29580 HUDSON DRIVE JSP22-54

Consideration of 29580 Hudson Drive for Preliminary Site Plan approval. The subject property contains 1.09 acres and is located in Section 4 of the City (Unit 5 of Beck North). The applicant is proposing to construct an 8,400 square foot, two-story warehouse and showroom for kitchenware and restaurant equipment. The site contains a significant presence of easements along the frontage of Hudson Drive.

Planning Review 29580 HUDSON DRIVE

Review Date: February 23, 2023
Review Type: Preliminary Site Plan Review
Project Name: **JSP22-54 29580 HUDSON DRIVE**
 50-22-04-378-004; North of West Rd, East of Hudson Dr
Plan Date: February 2, 2023
Prepared by: Christian Carroll, Planner
E-mail: ccarroll@cityofnovi.org **Phone:** (248) 735-5607

SHEET
Truck Maneuver Plan

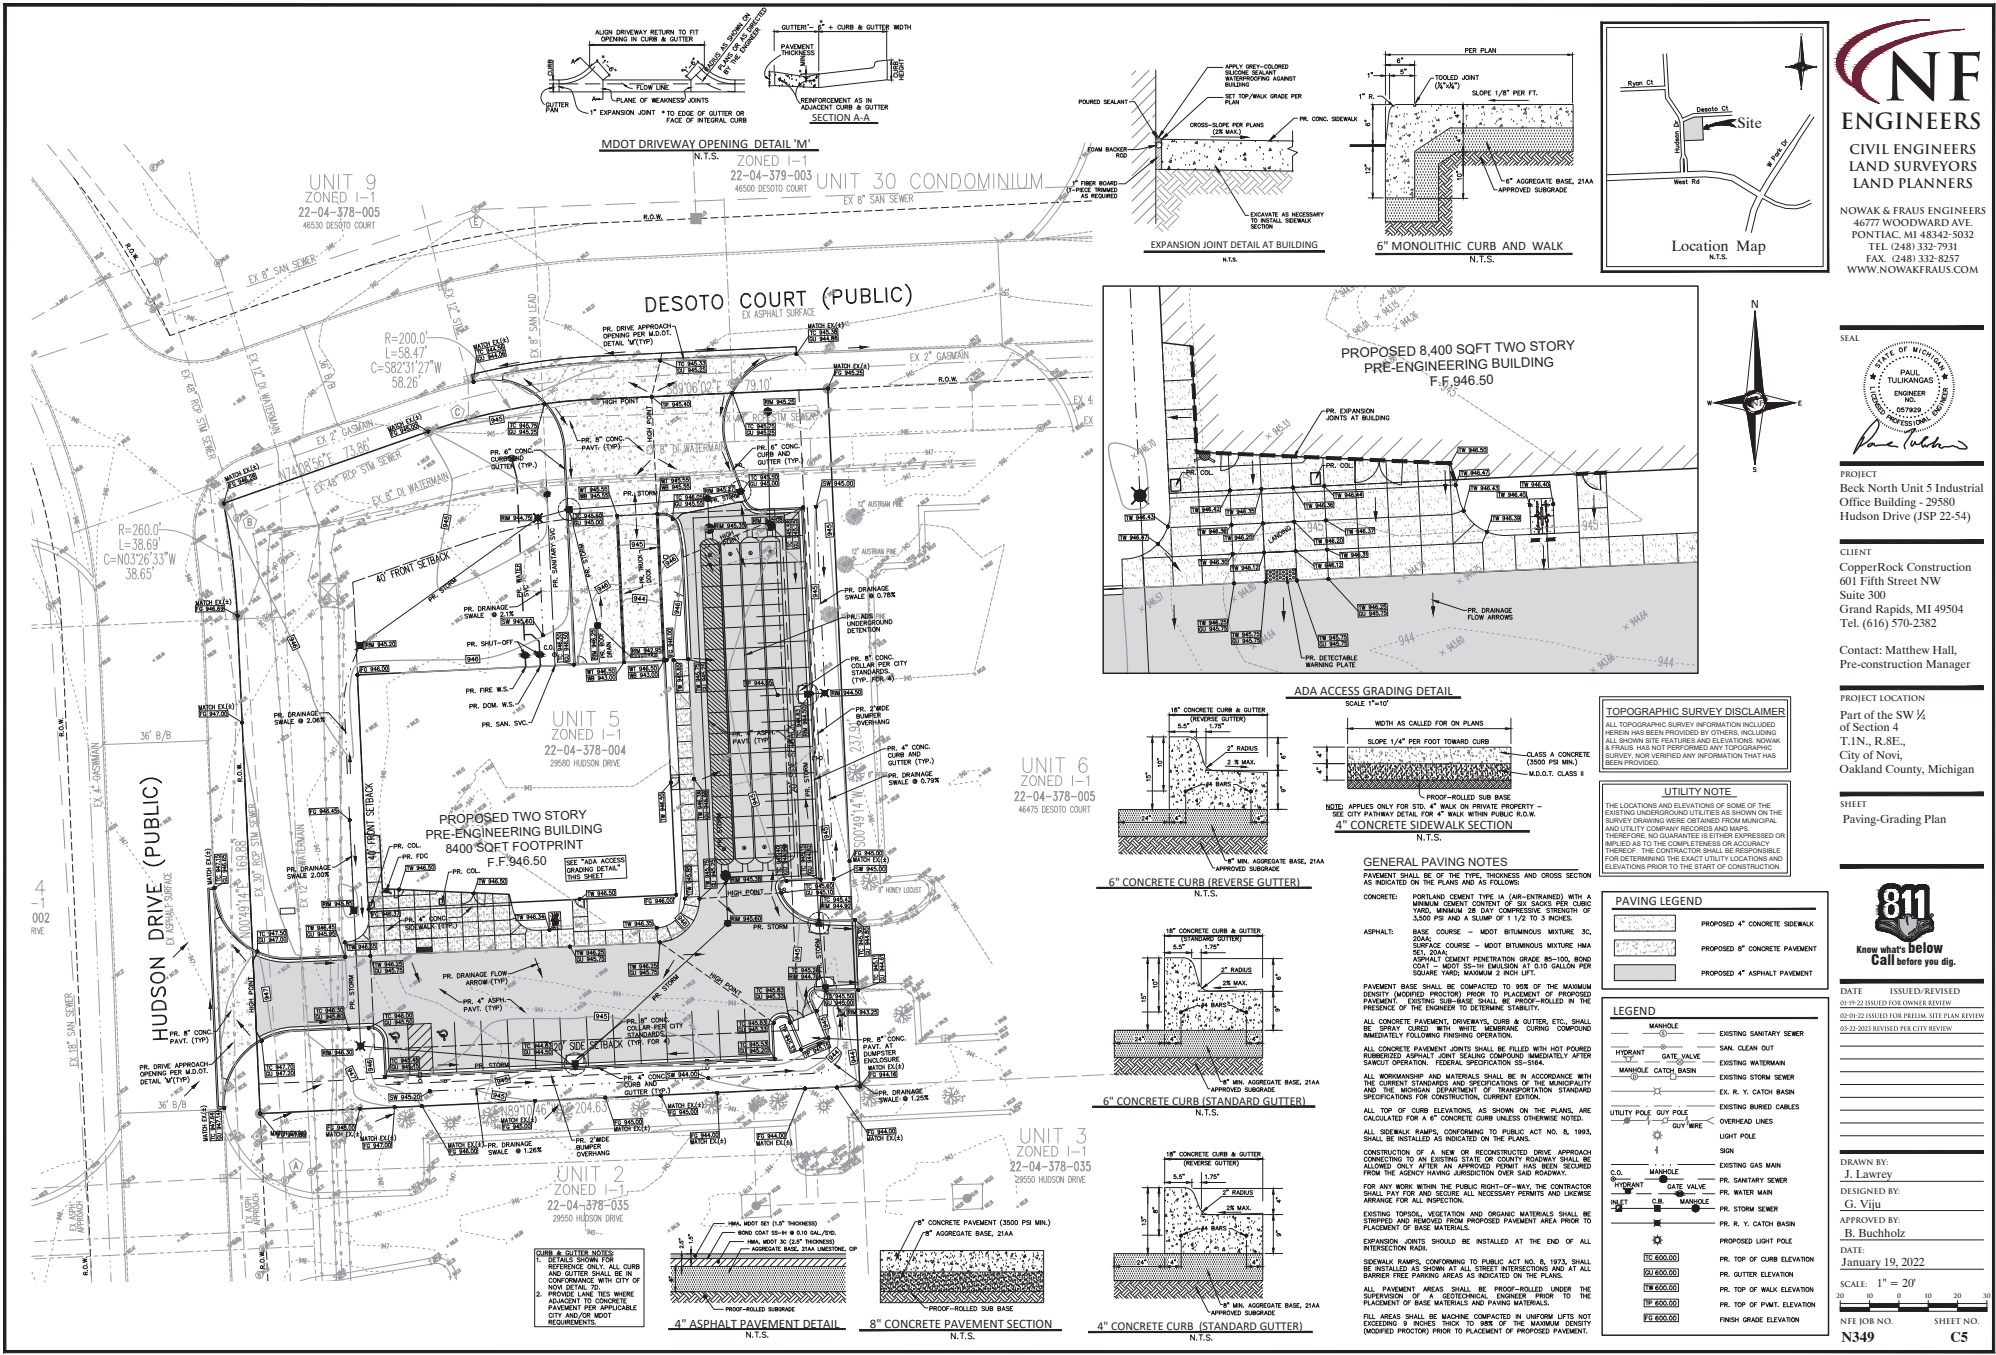
5. Loading Spaces (Sec. 5.4.3): Two proposed truck docks are located in the exterior side yard of the site, which is not permitted. **Please revise the location of the truck docks, or seek a variance from the Zoning Board of Appeals.**

SHEET
Utility Plan

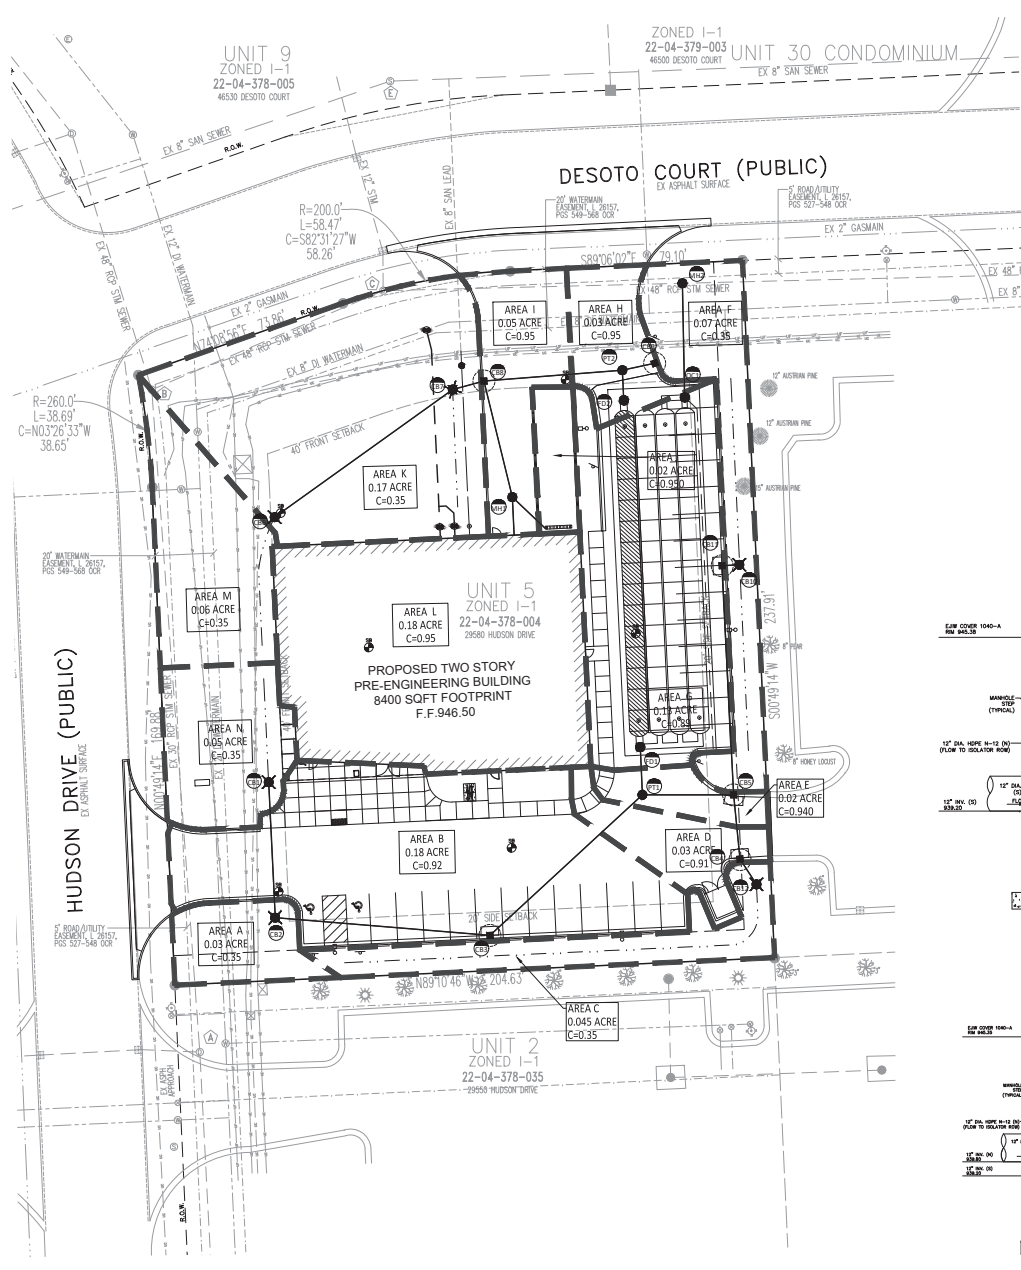
6. Provide a construction materials table on the utility plan listing the quantity and material type for each utility (water, sanitary and storm) being proposed.

7. Provide a utility crossing table indicating that at least 18-inch vertical clearance will be provided, or that additional bedding measures will be utilized at points of conflict where adequate clearance cannot be maintained.

29580 HUDSON DRIVE
PHOTOMETRIC SITE PLAN
PREPARED FOR: NOWAK & RAUS ENGINEERS
WWW.GASSERBUSH.COM

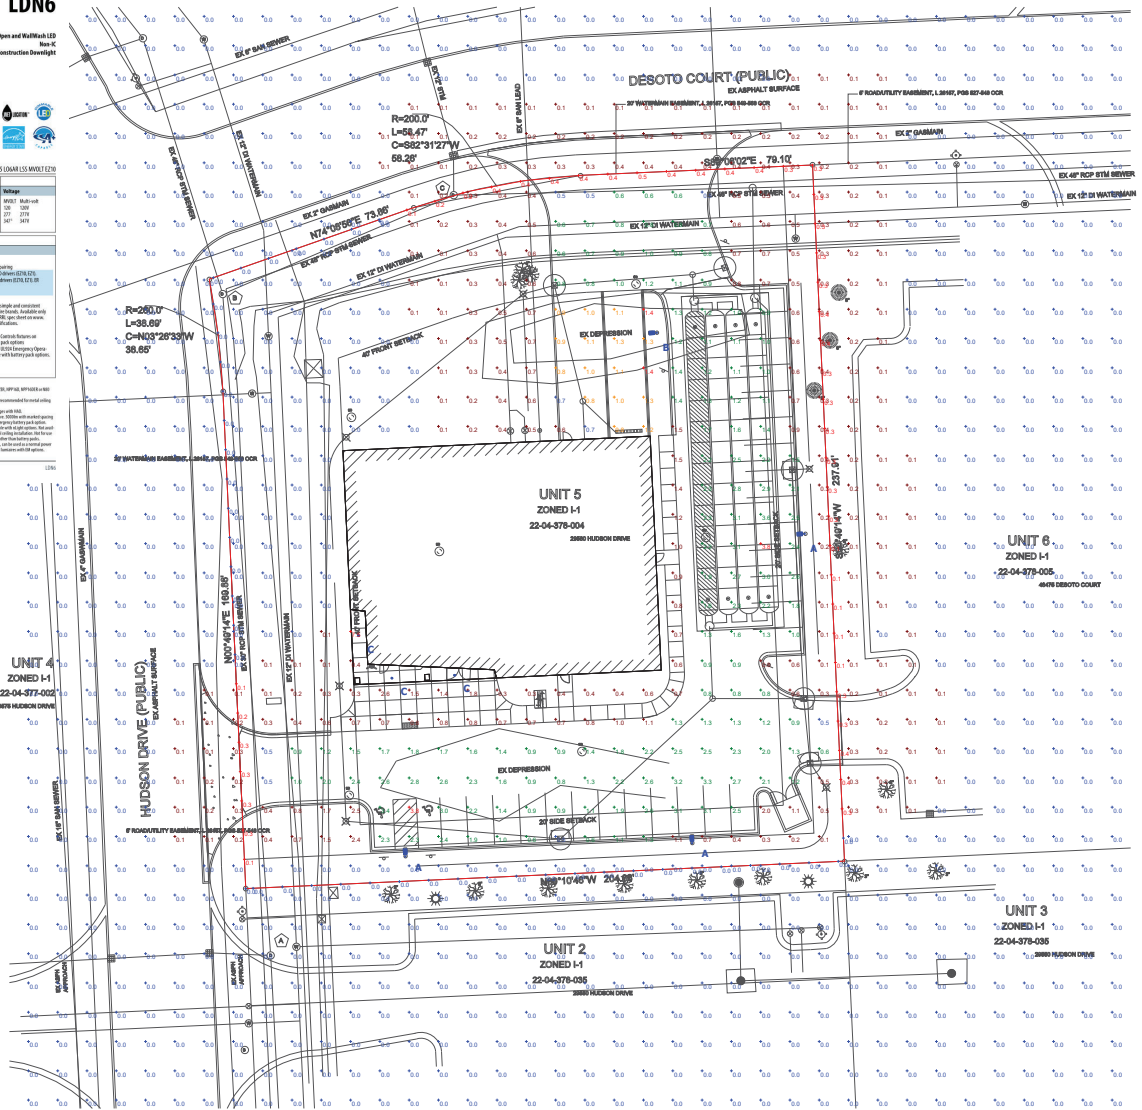
8. Security Lighting (Sec. 5.7.3.H): Standard noted related to any proposed security lighting have not been provided on the photometric plan. **Please provide these standard notes on the photometric plan with the next submittal.**

9. Minimum Illumination (Sec. 5.7.3.K): The minimum illumination requirements appear to be met for most of the site, except for the main entrance, which is shown as 0.3 foot candles. **Please revise the minimum illumination near the main entrance to a minimum of 1 foot candle.**

- The rear/east parking setback noted at 8.7 feet is not correct. This appears to be caused by confusion of the shown linear dimensions. The actual proposed eastern parking setback is 10.7 feet, which exceeds the minimum 10-foot parking setback requirements, and therefore no variance is required.
- The truck loading area remains proposed on the north side of the building, and a variance will be sought through the required ZBA process.
- A detail of the dumpster enclosure is provided on sheet C3.
- The project developer, Copperrock Construction, will provide economic impact information prior to the PC meeting.
- The project name has been revised as requested.
- The standard lighting notes have been added to the photometric plan as requested.
- The illumination at the main building entrance has been increased to meet minimum requirements. See details on photometric plan.
